ADDENDUM NO. 2

NOTICE TO BIDDERS OF PROJECT NO. 20223 RAY WILLIAMSON POOL IMPROVEMENTS – PHASE 1

Bainbridge Island Metro Park & Rec District: Ray Williamson Pool Improvements

A-0.1
 2208

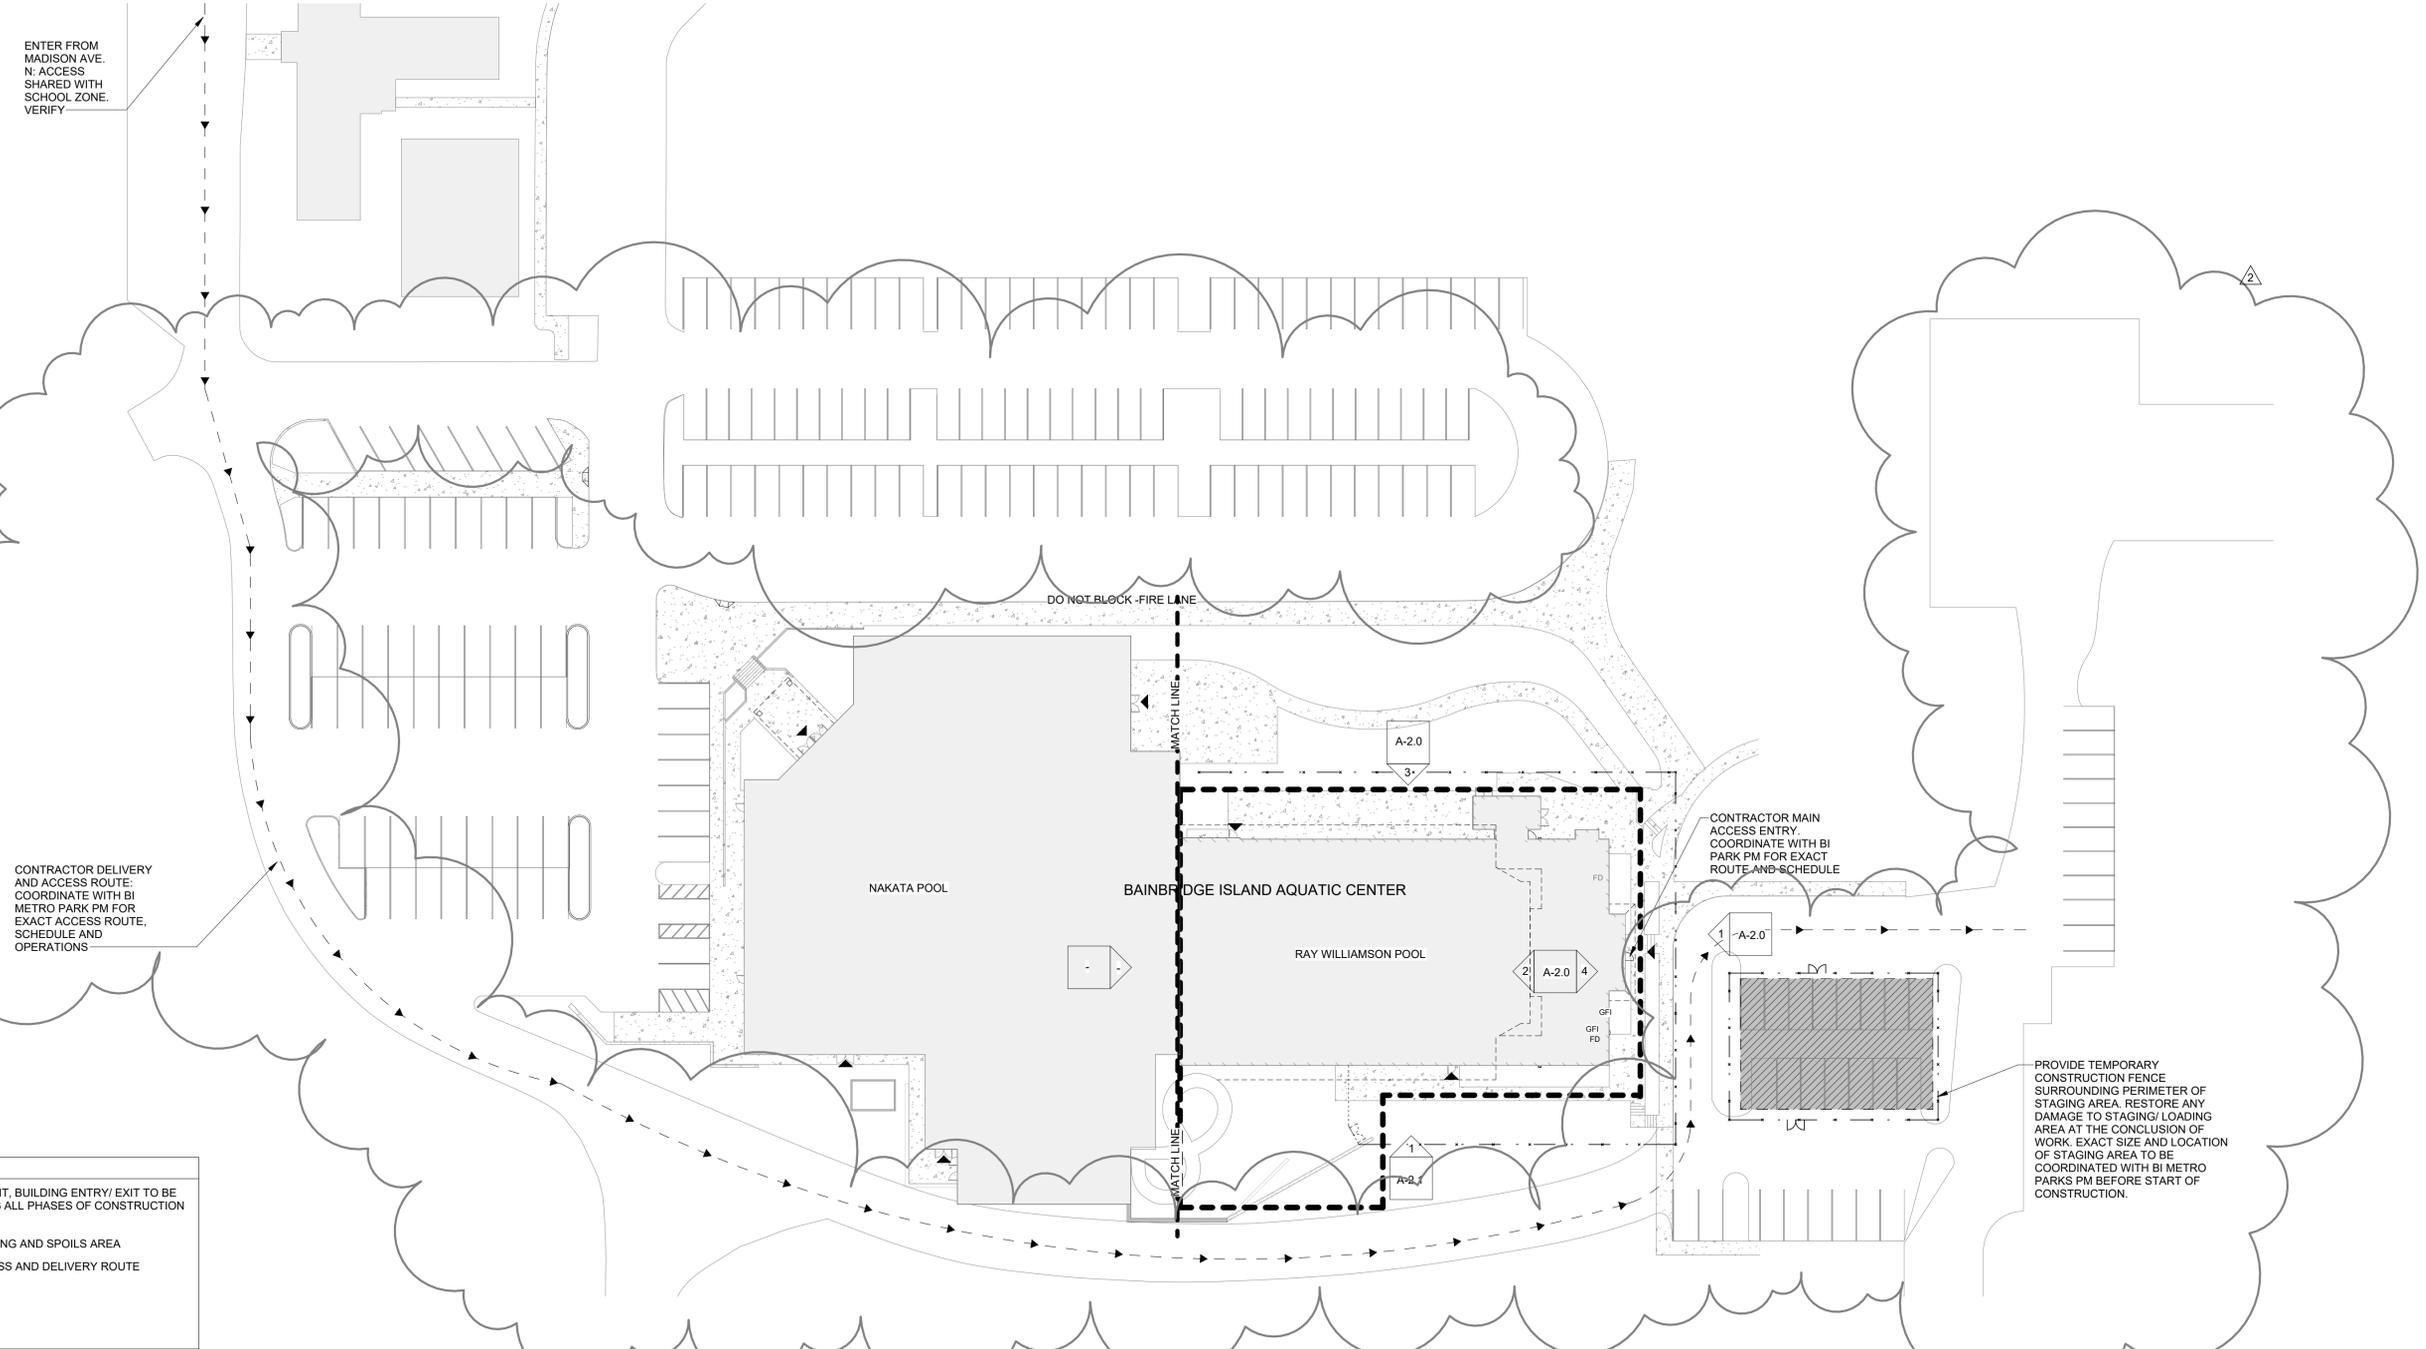
1. **DELETE** sheet A-0.1 Site Plan and **REPLACE** with sheet A-0.1 Site Plan in its entirety with revised Delivery and Access Route and Lay Down Area location, attached in Addendum No. 2.

CONTRACTOR DELIVERY AND ACCESS ROUTE. COORDINATE WITH BI METRO PARK PM FOR EXACT ACCESS ROUTE, SCHEDULE AND OPERATIONS

PROVIDE TEMPORARY CONSTRUCTION FENCE SURROUNDING PERIMETER OF STAGING AREA. RESTORE ANY DAMAGE TO STAGING/LOADING AREA AT THE CONCLUSION OF WORK. EXACT SIZE AND LOCATION OF STAGING AREA TO BE COORDINATED WITH BI METRO PARKS PM BEFORE START OF CONSTRUCTION.

AD-1.0
2208

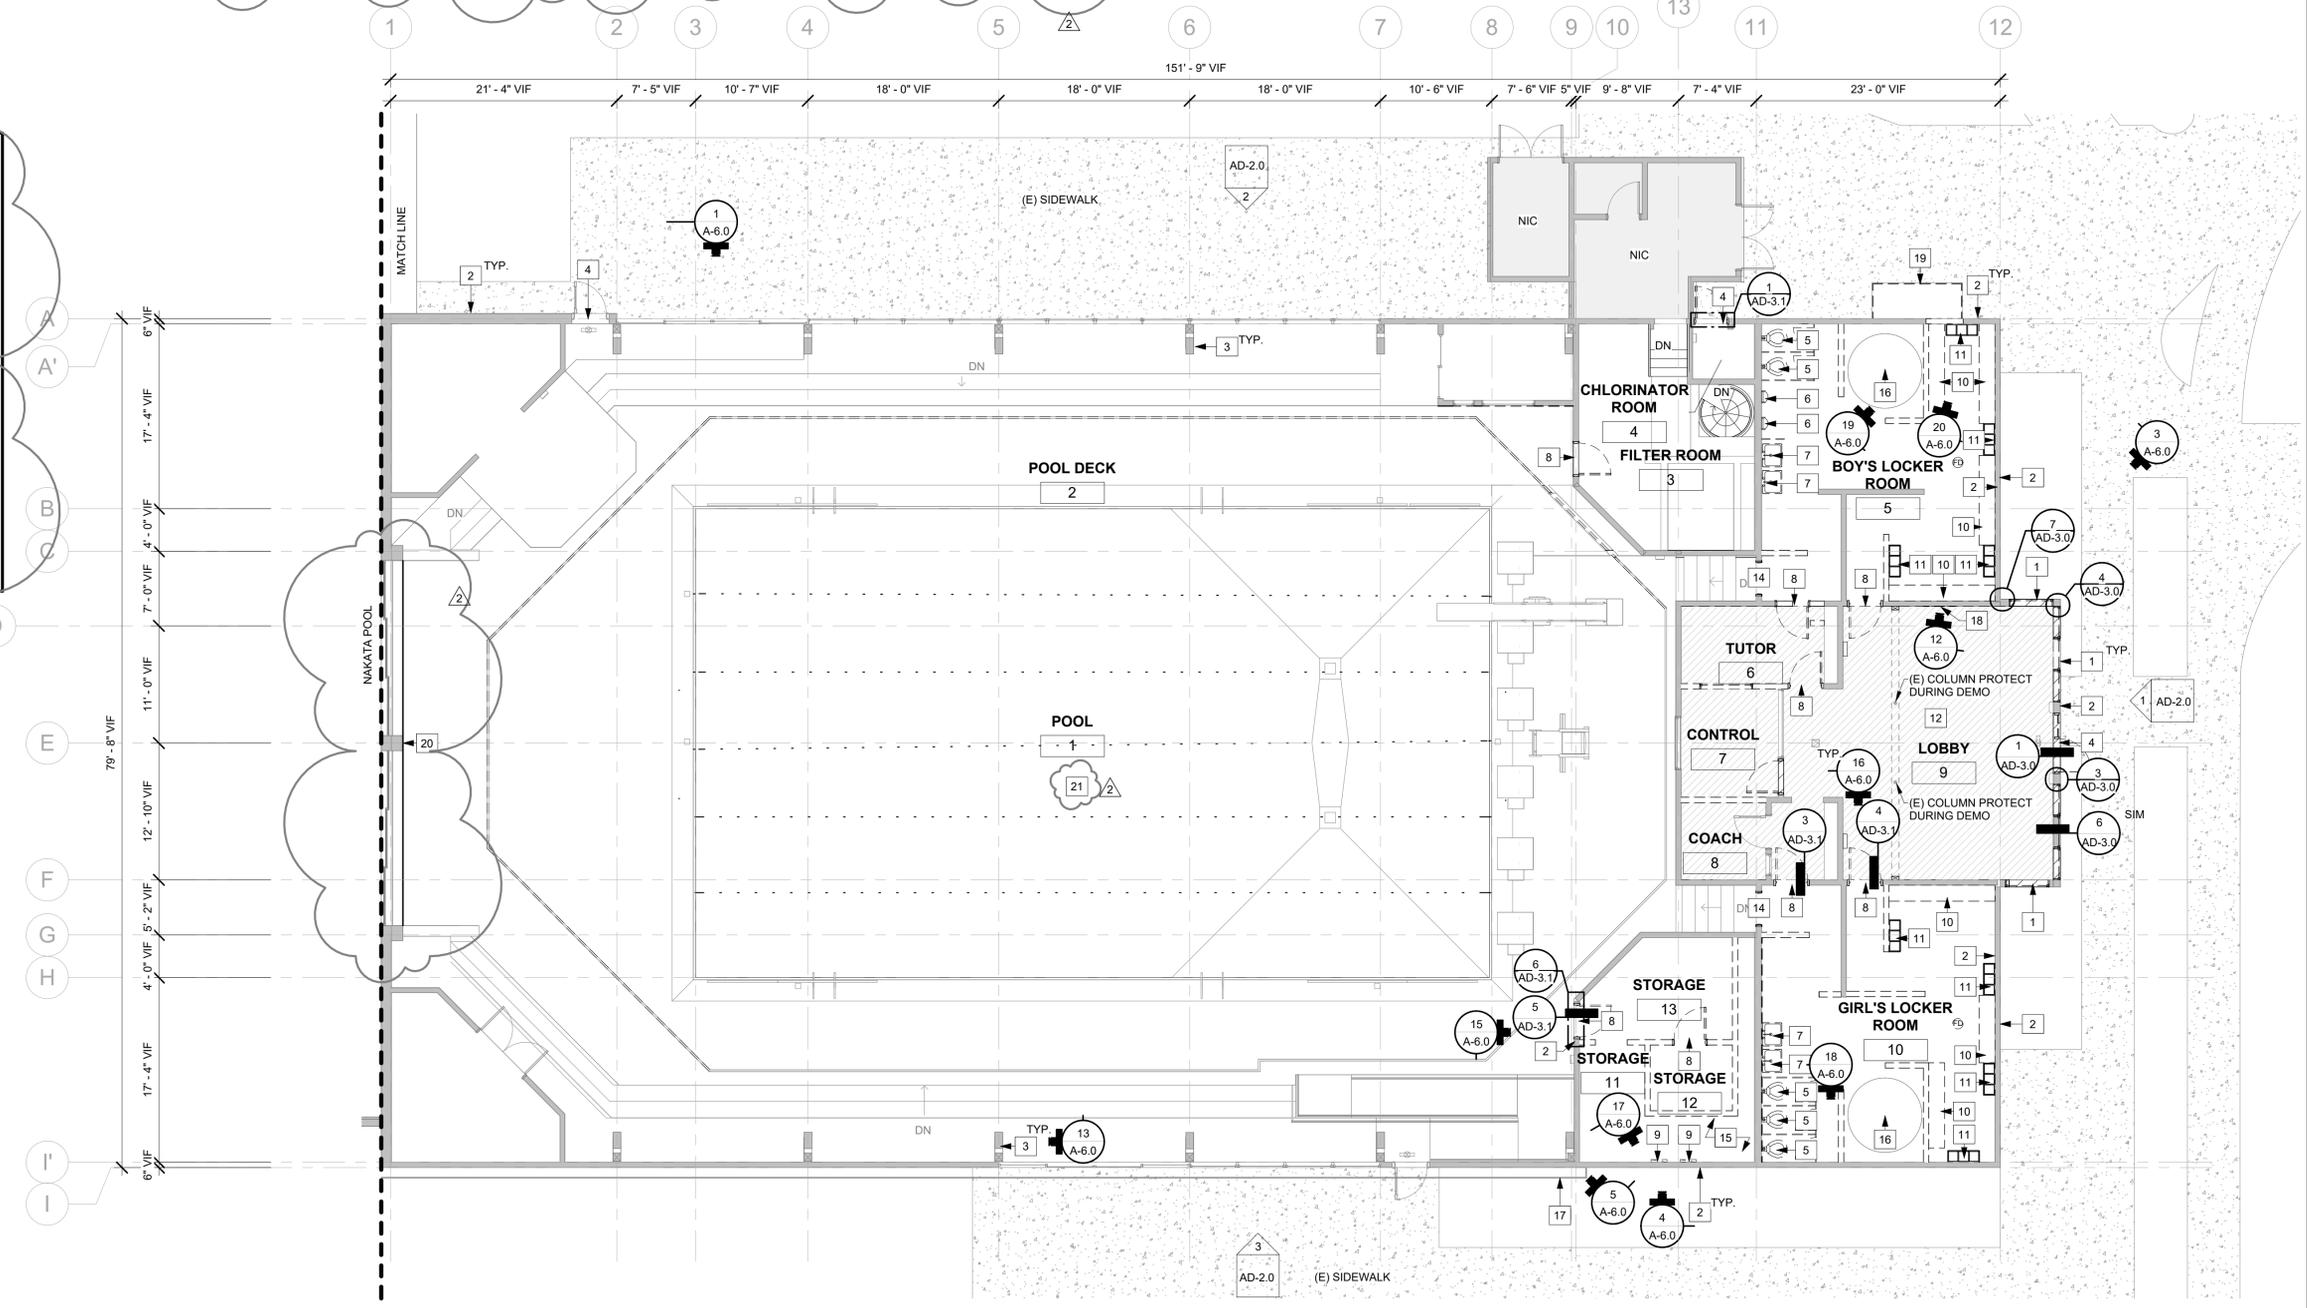
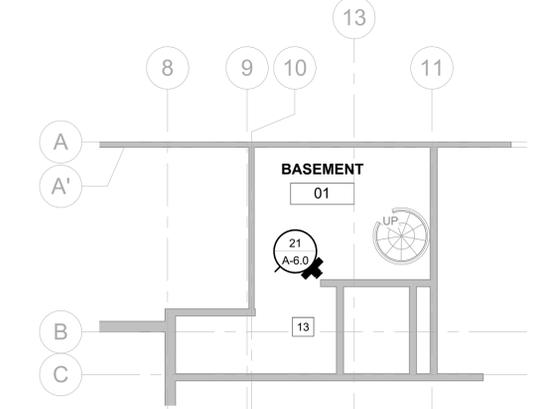
2. **DELETE** sheet AD-1.0 Demolition Plan and **REPLACE** with sheet AD-1.0 Demolition Plan in its entirety, attached in Addendum No. 2.

ADD note No. 5 to General Demolition Notes:

5. COORDINATE WITH OWNER TO SHUT DOWN THE HVAC SYSTEMS, THE CONTRACTOR SHALL COVER VENTS/ LOUVERS PRIOR TO DEMOLITION ACTIVITIES.

ADD Keynote No. 20 to Demolition Keynote Legend:

20. INSTALL PHYSICAL BARRIER AT THE NAKATA POOL AND RAY WILLIAMSON TRANSITION POINT. THE BARRIER MUST PROVIDE VISUAL BLOCKAGE BETWEEN THE TWO POOLS. CONTRACTOR MAY INSTALL VISUAL BARRIER TO (E) STOREFRONT; ANY DAMAGES AND REPAIRS TO THE STOREFRONT WILL BE THE RESPONSIBILITY OF THE CONTRACTOR FOR REPAIR/REPLACEMENT.

ADD Keynote No. 21 to Demolition Keynote Legend:

21. PROTECT POOL WITH AN ANCHORED COVER WITH BREATHABLE KNITTED FABRIC. COVER SYSTEM MUST ALSO CONFORM WITH SAFETY REQUIREMENTS AND PREVENT ENTRAPMENT. ADD ADDITIONAL PROTECTION MATERIAL SUCH AS VISQUENE TO PREVENT DIRT AND DEBRIS FROM ENTERING THE POOL. BASIS OF DESIGN: Covers&all Rectangular Pool Cover – Center Steps 47’x78’ (F.V.) or approved equal.

ADD Hazardous Materials Abatement Notes:

AD-2.0
2208

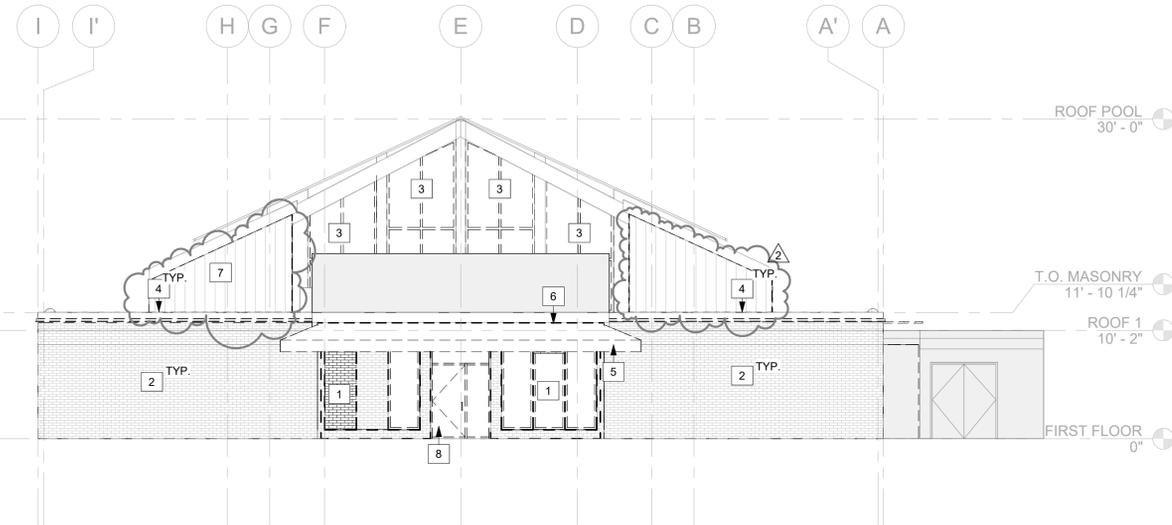
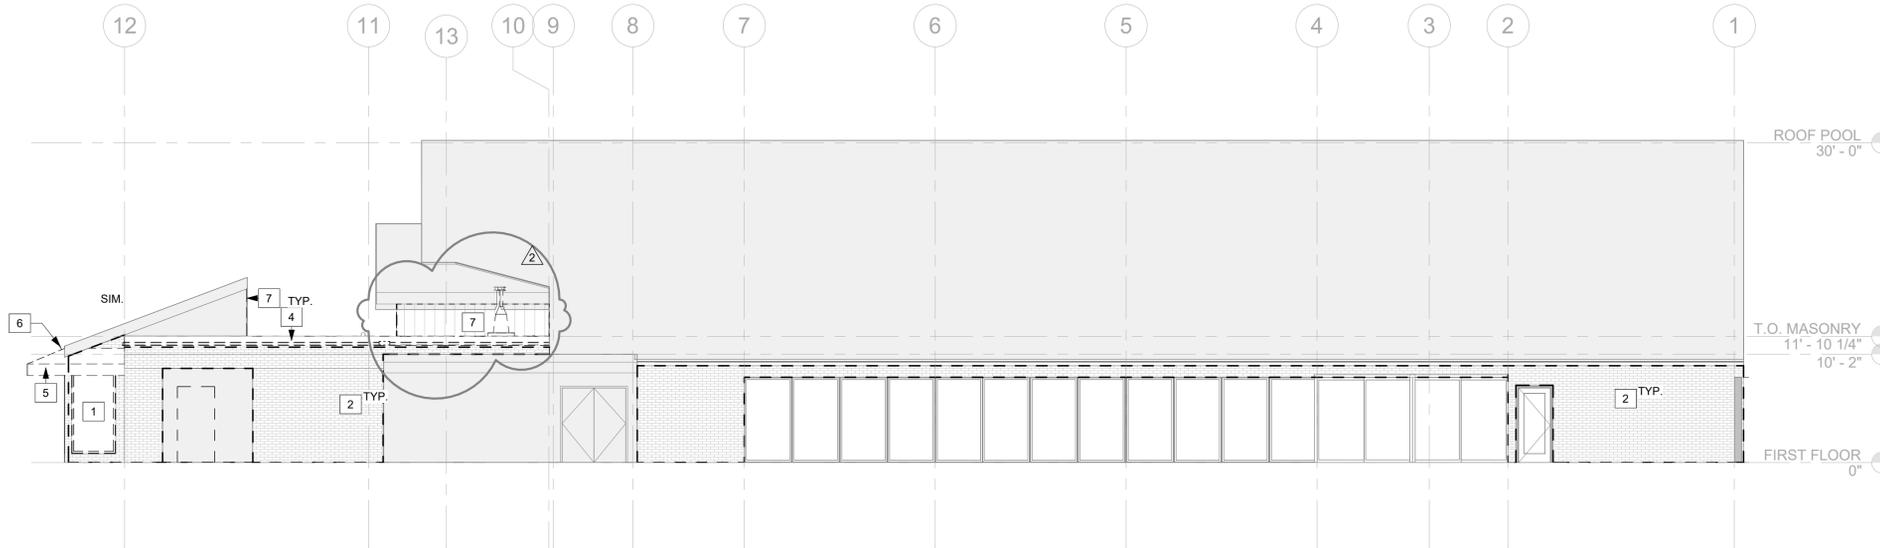
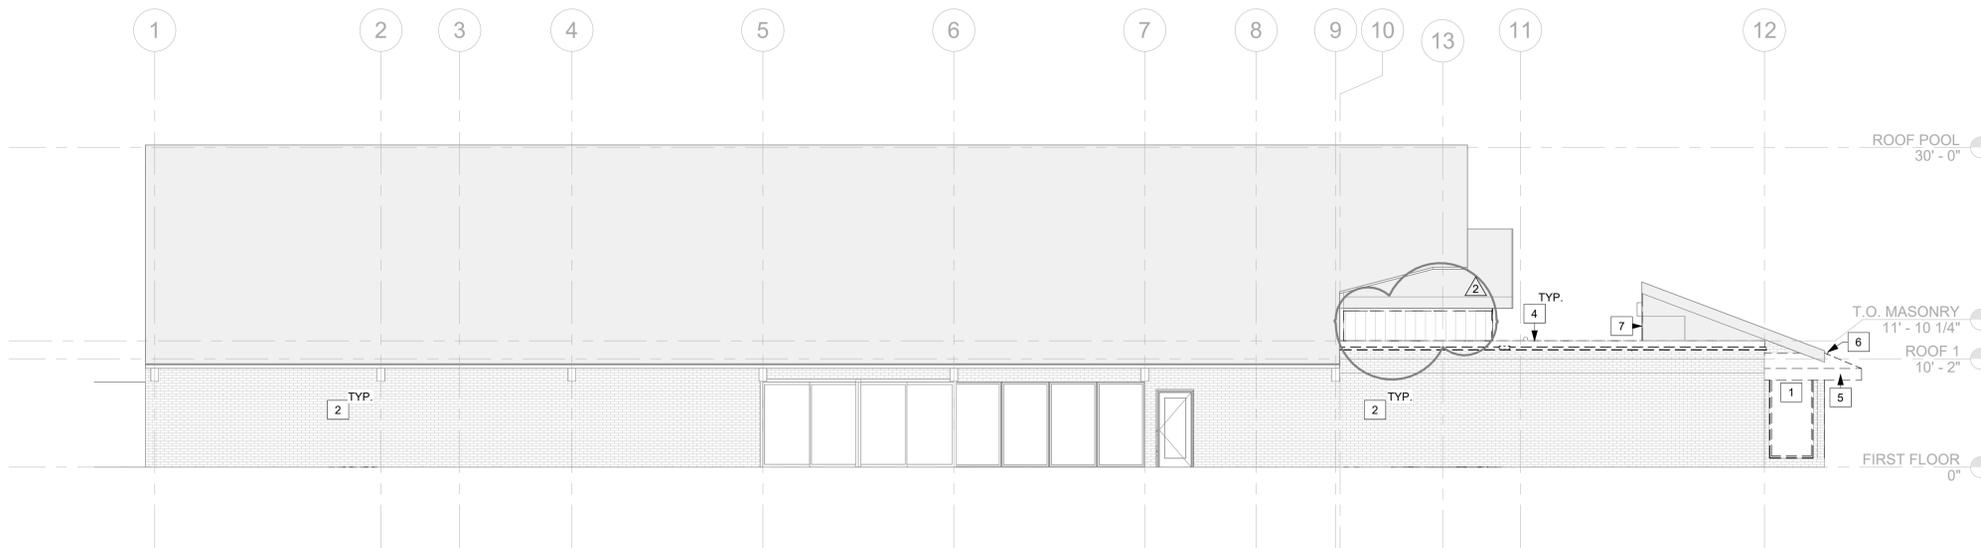
3. **DELETE** sheet AD-2.0 Exterior Elevation Demo and **REPLACE** with sheet AD-2.0 Exterior Elevation Demo in its entirety, attached in Addendum No. 2.
DELETE Keynote No. 7 on Demo Exterior Keynote Legend and **REPLACE** with Keynote No. 7.

7. DEMOLISH (E) T1-11 SIDING.
4. **DELETE** sheet **AD-3.3** Roof Demo Details and **REPLACE** with sheet **AD-3.3** in its entirety, attached in Addendum No. 2.
ADD note to details 9/AD-3.3, 11/AD-3.3 and 12/AD-3.3: DEMO (E) T1-11 SIDING.
